ATTACHMENT 2 TO AEP:NRC:1120
PROPOSED REVISED TECHNICAL SPECIFICATION PAGES

ANALYSIS OF MAIN STEAM LINE BREAK
INSIDE CONTAINMENT (WCAP-11902 SUPPLEMENT 1)

INCREASED POWER AND REVISED
TEMPERATURE AND PRESSURE OPERATION
FOR
DONALD C. COOK NUCLEAR PLANT
UNITS 1 & 2
LICENSING REPORT

Figure S-3.4-1 - 4.6 ft² Double-Ended Rupture, 102% Power, MSIV Failure

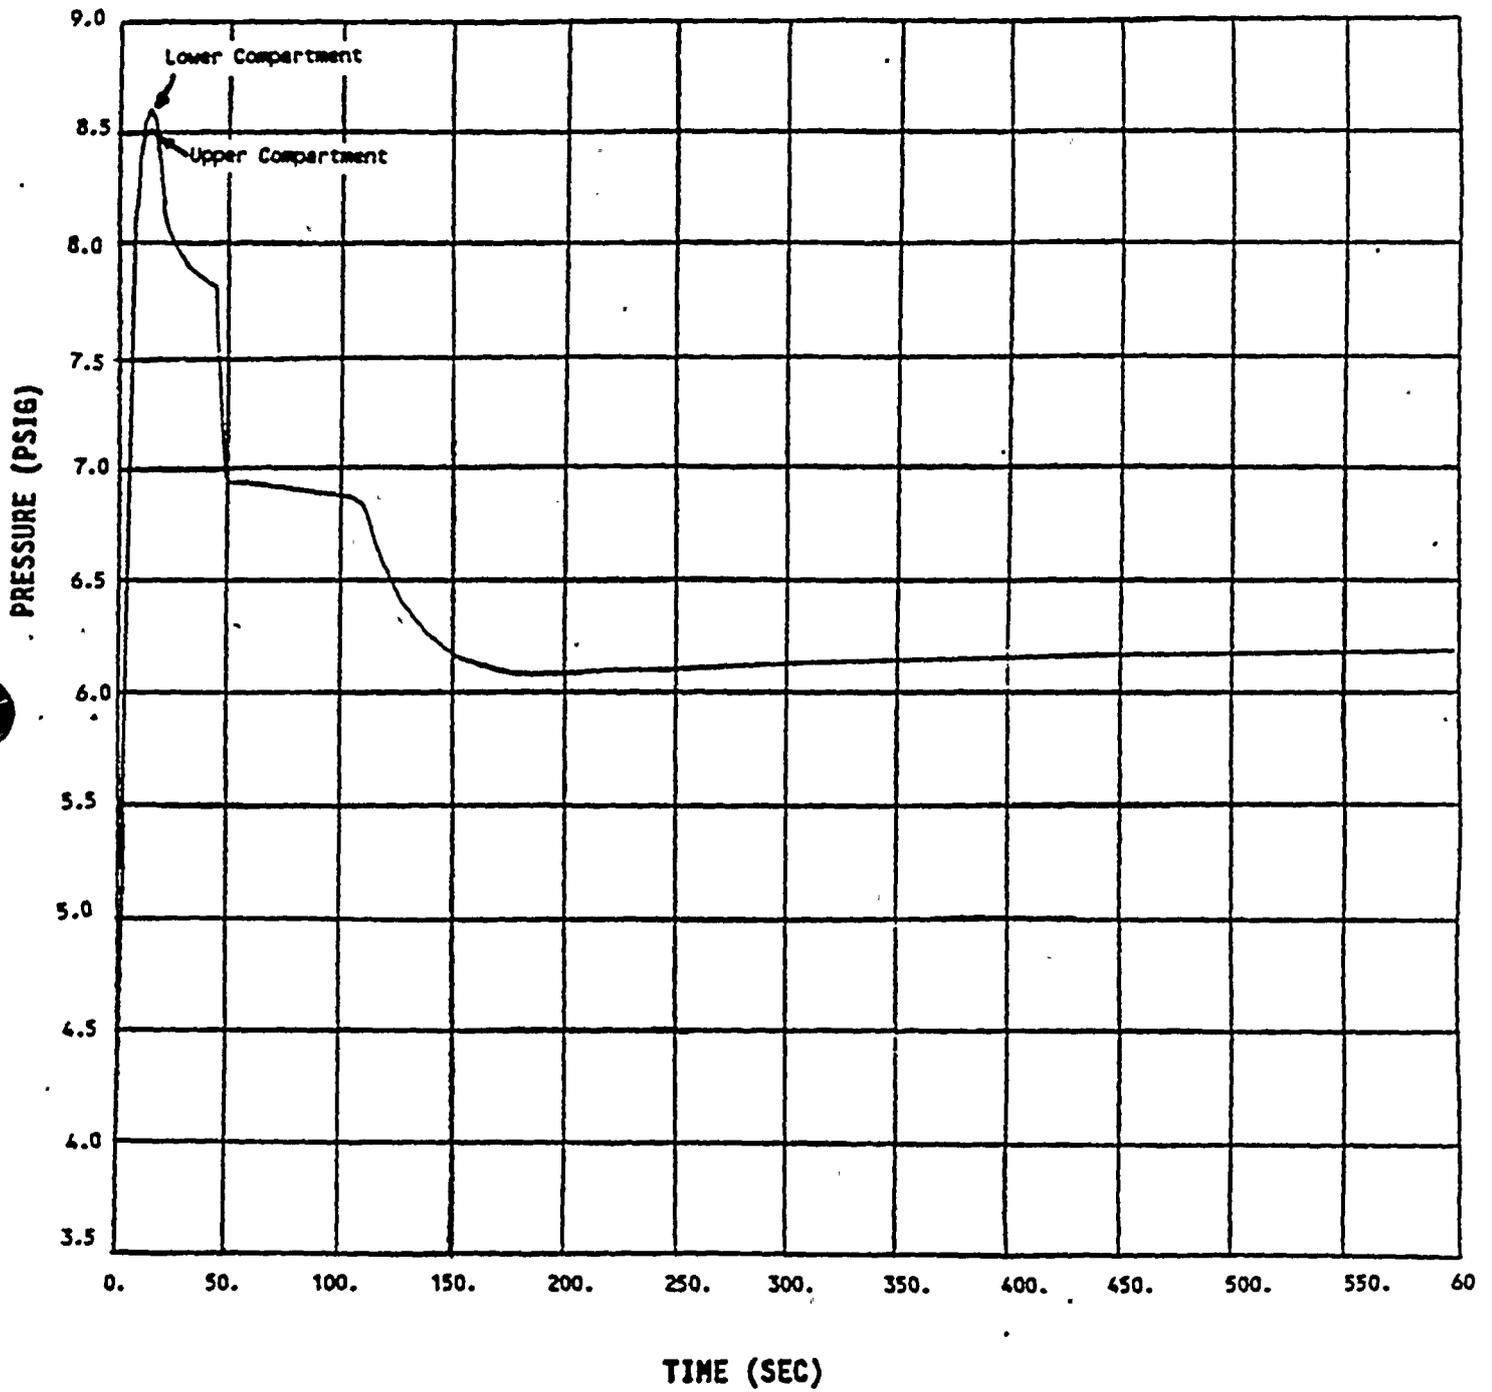
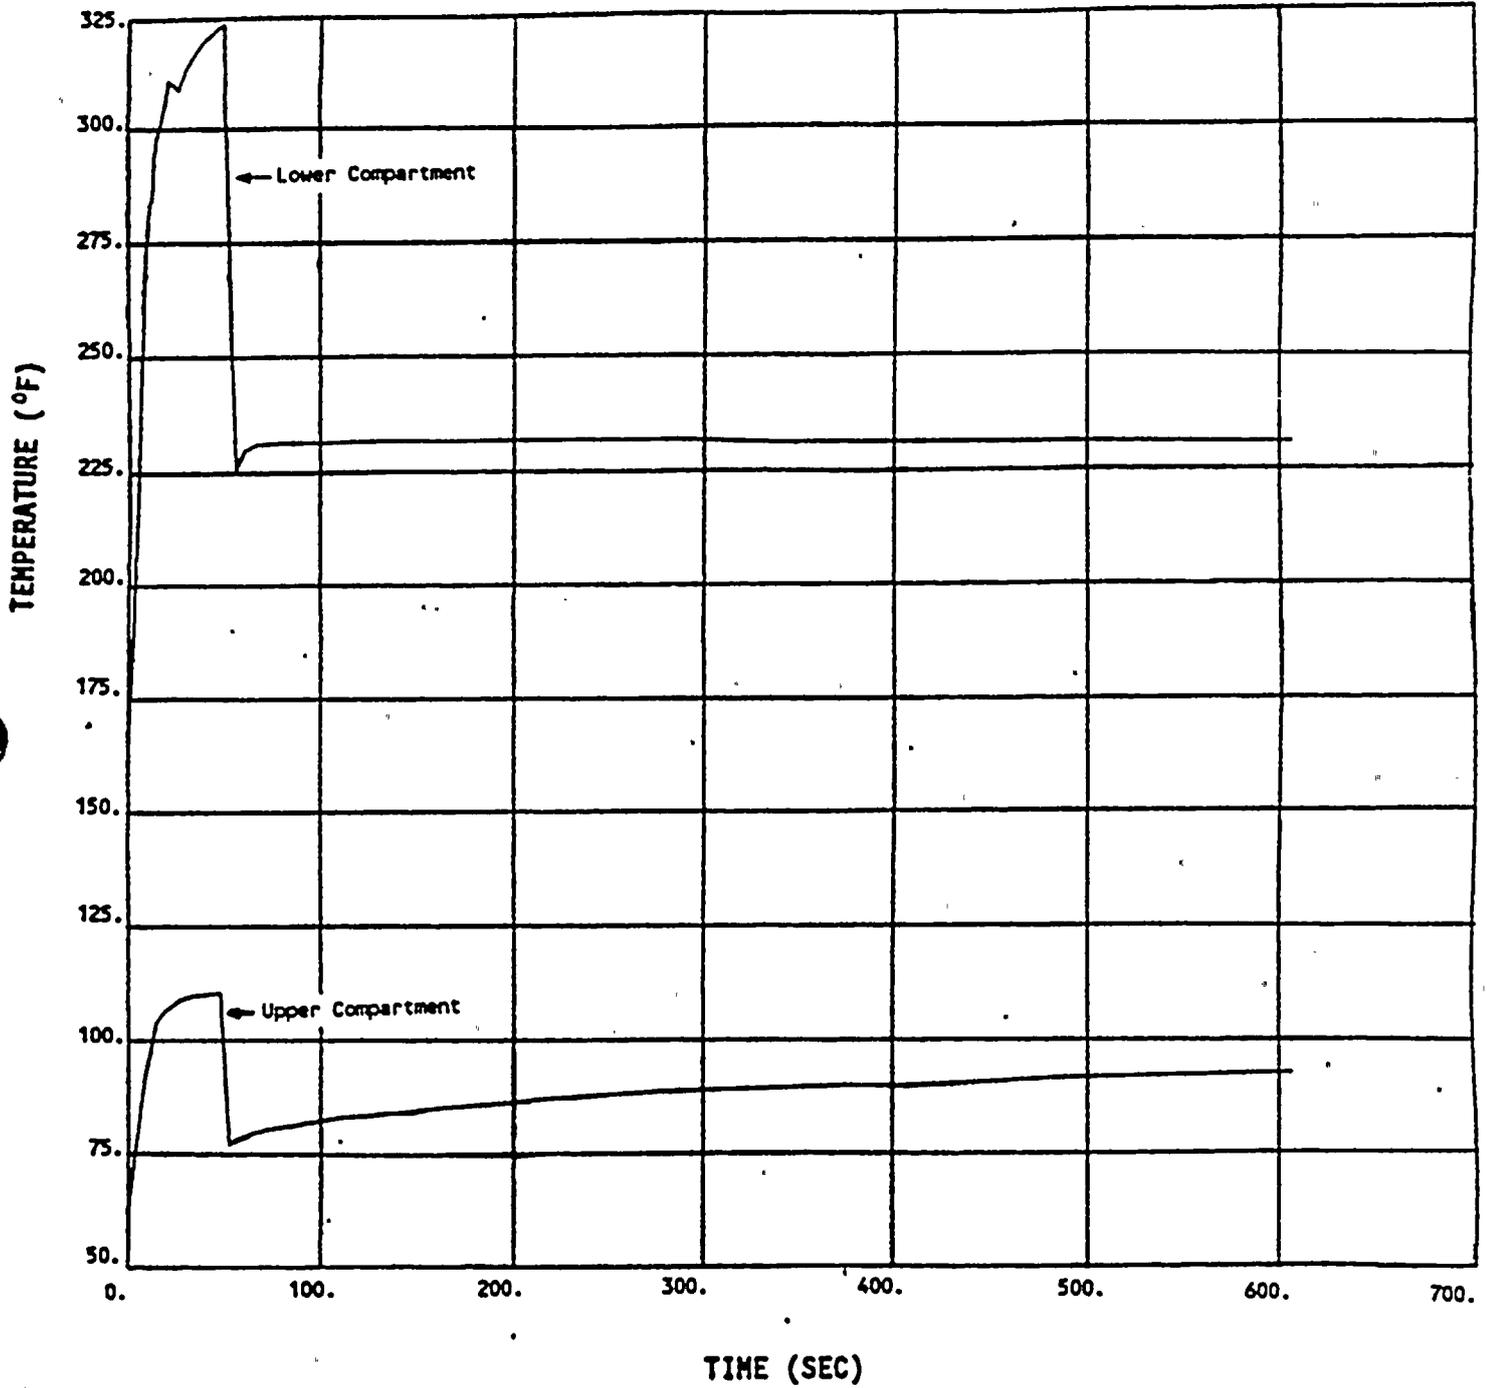
The results of the analysis show that the maximum calculated containment temperature is 324.9°F for the 4.6 ft² double ended rupture at 102% of the full power. The mass and energy calculations for this case are based on the main steam isolation valve failure.

The maximum containment temperature calculated for the limiting small split break (0.86 ft² at 102% of full power) is 324.4°F. The auxiliary feedwater runout protection failure is assumed for this case. Table S-3.4-1 and Figures S-3.4-1 through S-3.4-4 show the results for the two limiting cases.

Figure 3.3-52 Safety Injection Flow Supplied by One Charging Pump

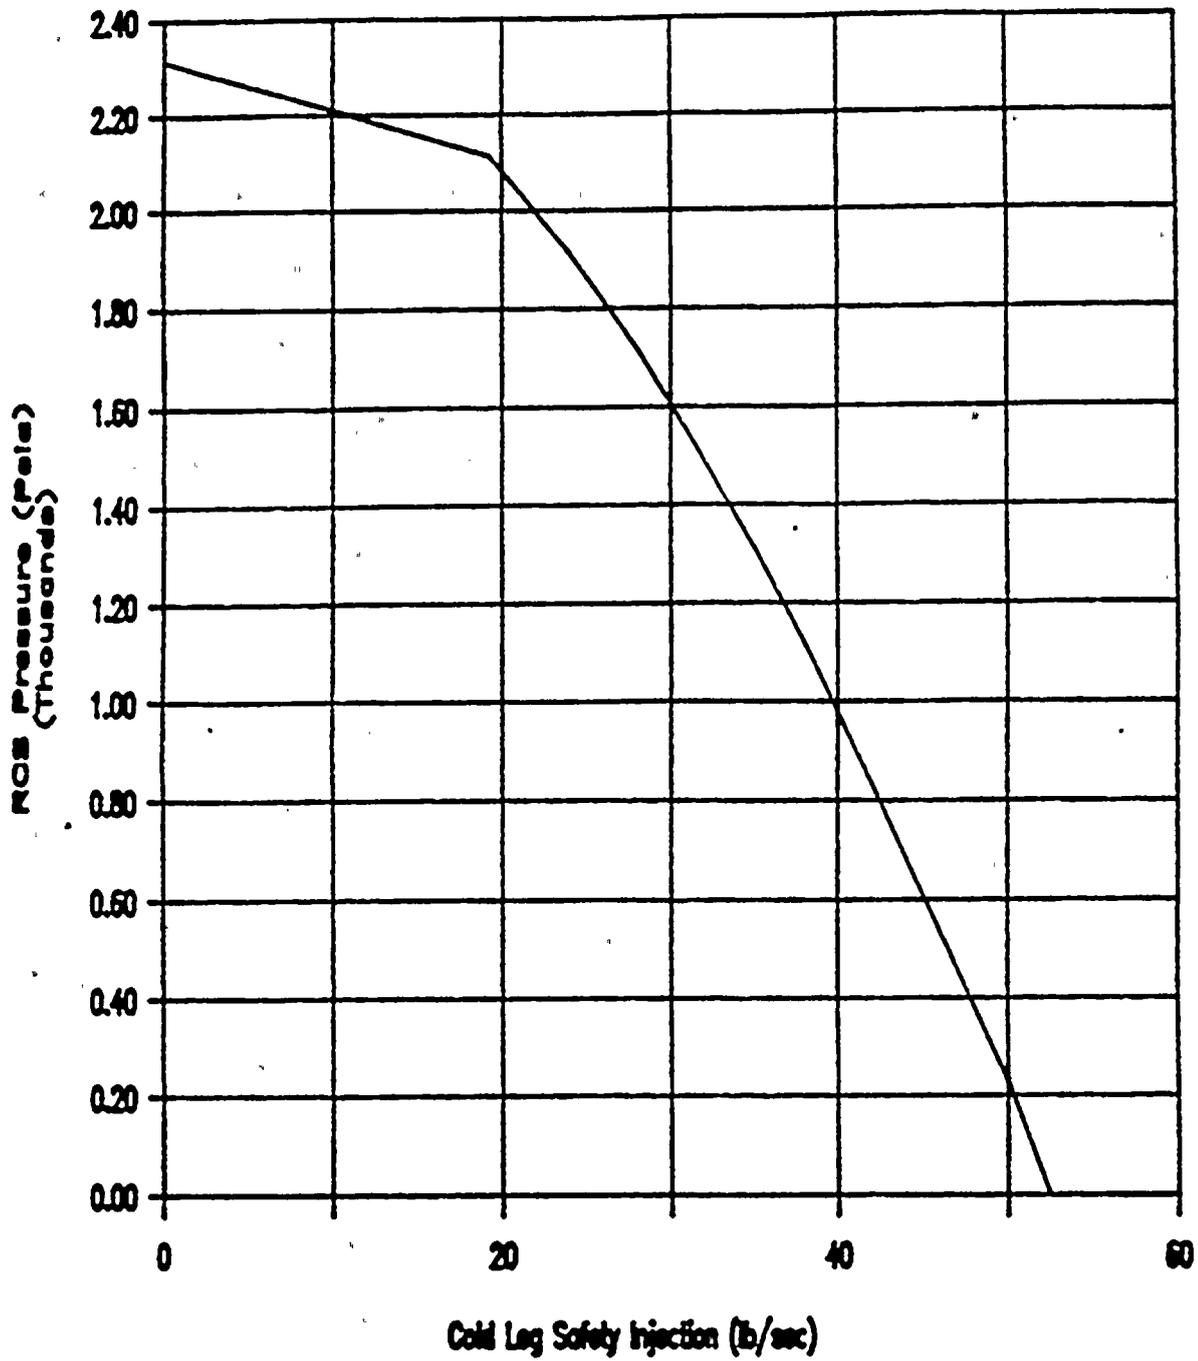
The modeling of the safety injection system in LOFTRAN is described in Reference 2. Figure 3.3-52 of WCAP-11902 presents the safety injection flow rates as a function of RCS pressure assumed in the analysis. The flow corresponds to that delivered by one charging pump delivering its full flow to the cold legs. The safety injection flows assumed in this analysis take into account the degradation of the ECCS charging pump performance. No credit has been taken for any borated water that might exist in the injection lines, which must be swept from the lines downstream of the boron injection tank isolation valves prior to the delivery of boric acid to the reactor coolant loops. For this analysis, a boron concentration of 0 ppm for the boron injection tank is assumed.
